Southern Nuclear Operating Company  
Vogtle Electric Generating Plant Units 3 and 4  
Request for License Amendment and Exemption:  
Changes to the Primary Sampling System (PSS) (LAR-12-012)

License Amendment Request (LAR-12-012): Primary Sampling System (PSS) Changes

**Request for License Amendment  
Regarding Changes to the Primary Sampling System  
(LAR-12-012)**

Figure 2.2.1-1  
Containment System

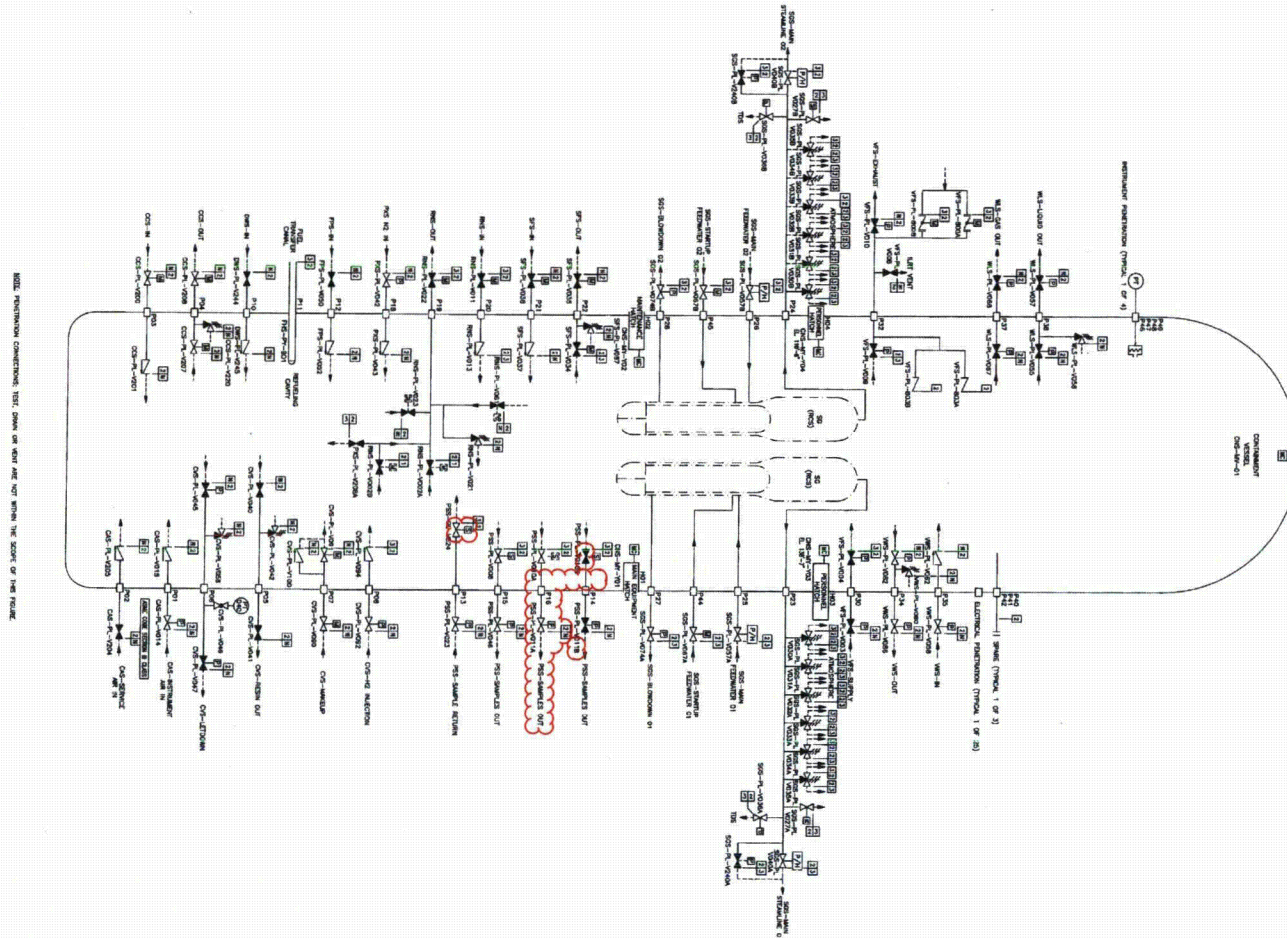
Tier	UFSAR Departure	Description of Change
UFSAR Tier 1	Figure 2.2.1-1	Remove the existing sample line at the discharge line of valve PSS-PL-V010A and change the discharge of valve PSS-PL-V010A to a new additional containment penetration P16 and containment isolation valve PSS-PL-V011A. The existing PSS-PL-V011 is renamed PSS-PL-V011B
UFSAR Tier 1	Table 2.2.1-2	Add PSS-PL-T005A/B, PSS-PL-T031, and PSS-PL-L038
UFSAR Tier 1	Table 2.3.13-1	Rename PSS-PL-V011 to PSS-PL-V011B and add a liquid sample line containment isolation valve PSS-PL-011A with valve description and requirements. Adjust ORC/IRC descriptions
UFSAR Tier 1	Figure 2.3.13-1	Remove the sample line between the discharge of PSS-PL-V010B and PSS-PL-V010A, relocate PSS-PL-V001B next to PSS-PL-V001A, add an additional containment penetration and containment isolation valve ORC, PSS-PL-V011A, to the discharge line of valve PSS-PL-V010A, and change the name of PSS-PL-V011 to PSS-PL-011B.

- Figure 2.1.1-1, Containment System,
  - Revised to show PSS-PL-V024 valve type as an SOV
  - Remove the existing sample line at the discharge of valve PSS-PL-V010A

Figure 2.3.13-1  
Primary Sampling System

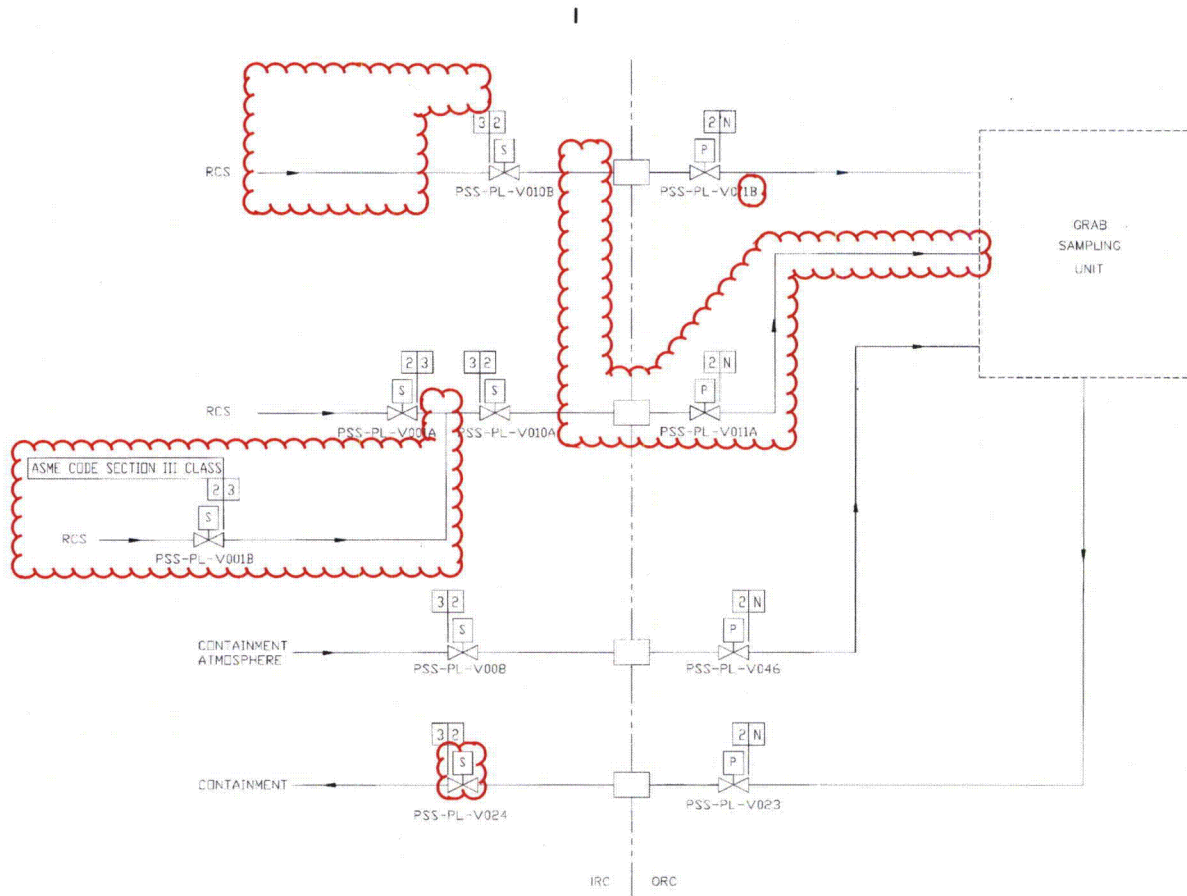
- Figure 2.3.13-1
  - Show PSS-PL-V024 valve type as an SOV
  - Remove the sample line between the discharge of PSS-PL-V010B and PSS-PL-V010A

- Change the tag number of PSS-PL-V011 to PSS-PL-V011B
- Add an additional containment penetration and containment isolation valve ORC, PSS-PL-V011A, to the discharge line of valve PSS-PL-V010A
- Relocate PSS-PL-V001B next to PSS-PL-V001A

Figure 11.5-3

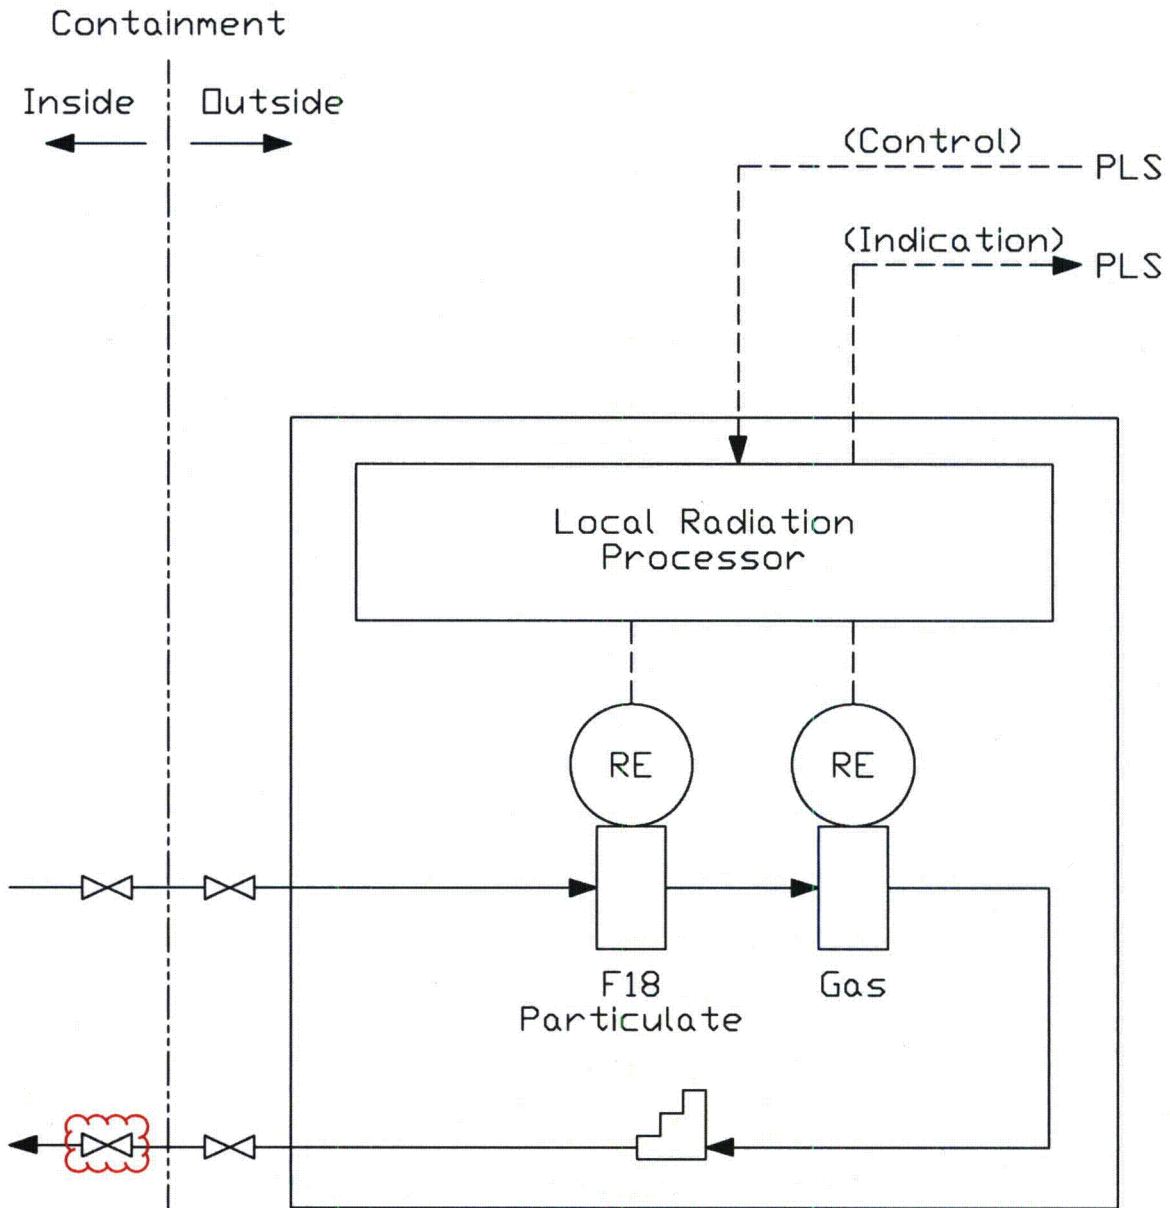
Tier	UFSAR Departure	Description of Change
UFSAR Tier 2	Table 3.9-12	Revise PSS-PL-V024 valve description
UFSAR Tier 2	Table 3.9-16	Revise PSS-PL-V024 valve description and IST requirements and notes
UFSAR Tier 2	Table 3.11-1	Revise PSS-PL-V024 valve description and requirements
UFSAR Tier 2	Table 3I.6-2	Revise PSS-PL-V024 valve description and requirements
UFSAR Tier 2	Table 6.2.3-1	Add PSS-PL-V024 requirements
UFSAR Tier 2	Figure 9.3.3-1	Revise PSS-PL-V024 valve type to SOV.
UFSAR Tier 2	Table 9A-2	Add PSS-PL-V024 requirements
UFSAR Tier 2	Figure 11.5-3	Revise check valve symbol to valve symbol
